AGENDA
PLANNING AND ZONING MEETING
Norwalk City Hall, 705 North Ave
Monday, September 25, 2017
5:45 P.M.

**PLANNING & ZONING COMMISSION
AGENDA STATEMENT**

ITEM TITLE: Request from Sunset Crest LLC to approve a site plan for the Sunset Crest site at 1329 Sunset Drive

BUFFER WALL DETAIL
NO SCALE

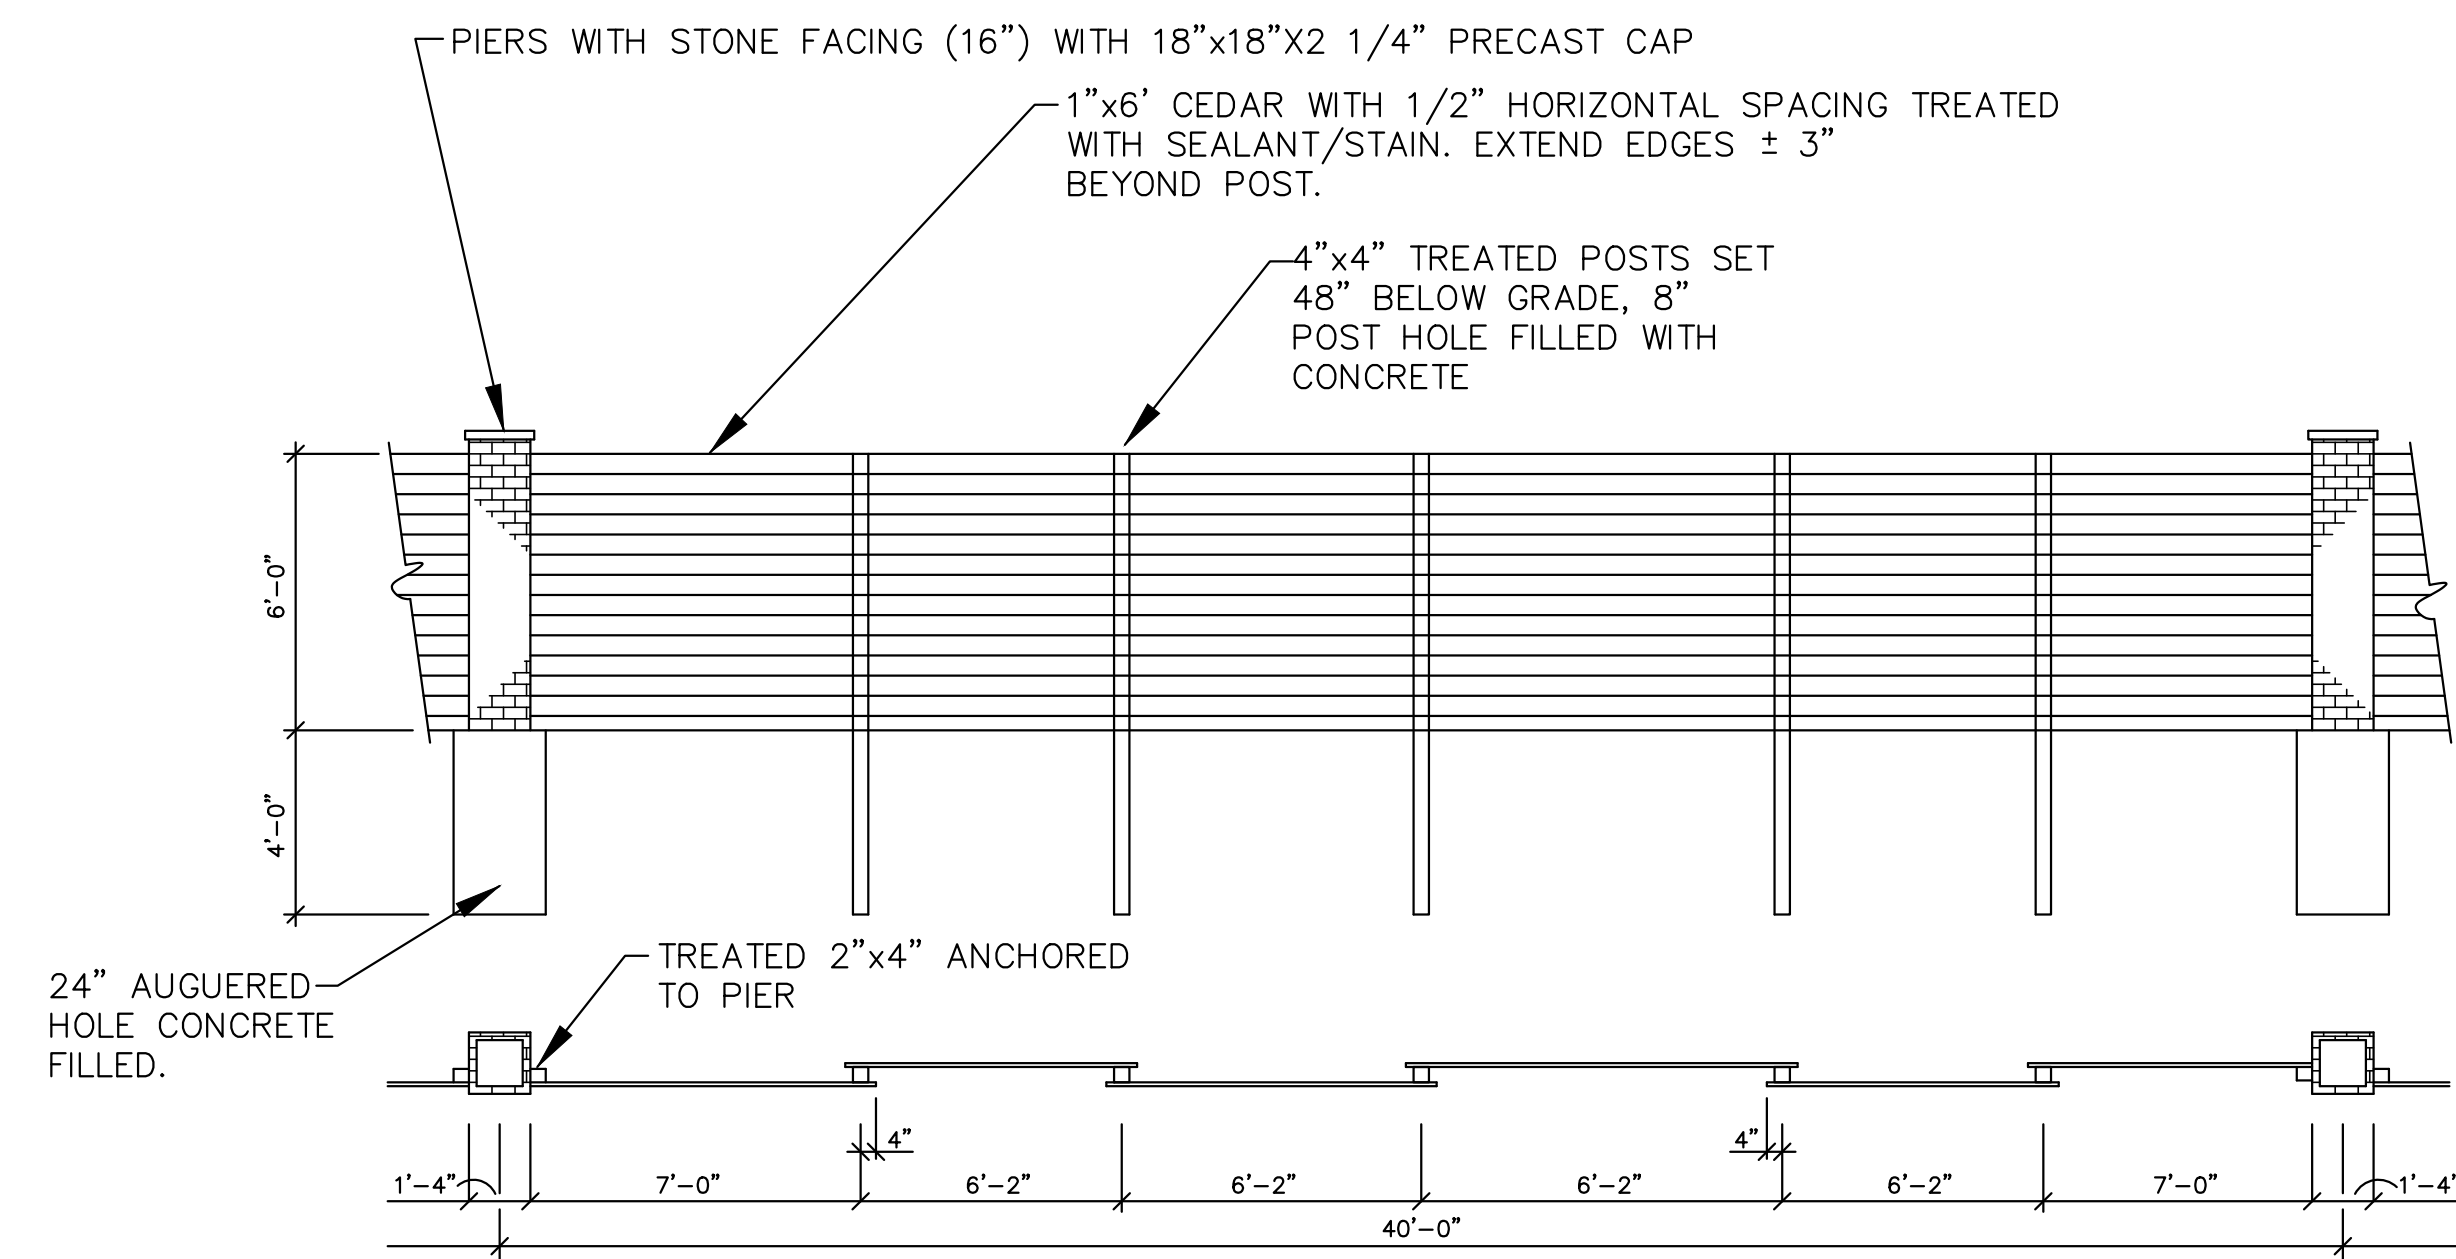
The site plan shows the installation of a buffer wall along the western property line. The site plan does not show an adequately designed buffer wall. Code requires that a buffer wall be constructed of a permanent low maintenance material such as concrete block, cinder block, brick, concrete, precast concrete, tile block, etc.

Overall the site plan meets the City's requirements for development of an C-2 parcel. The developer needs to provide a new design for the rear buffer wall so that the buffer requirements are met. The City also needs to make a determination on façade materials utilized on the building.

- That the site development and building construction follow all City code regulations.
- That any significant modifications to the site plan be reviewed and approved by the Planning & Zoning Commission and City Council.
- That the buffer wall be redesigned to meet City requirements.

WHEREAS, that the buffer wall be redesigned to meet City requirements.; and
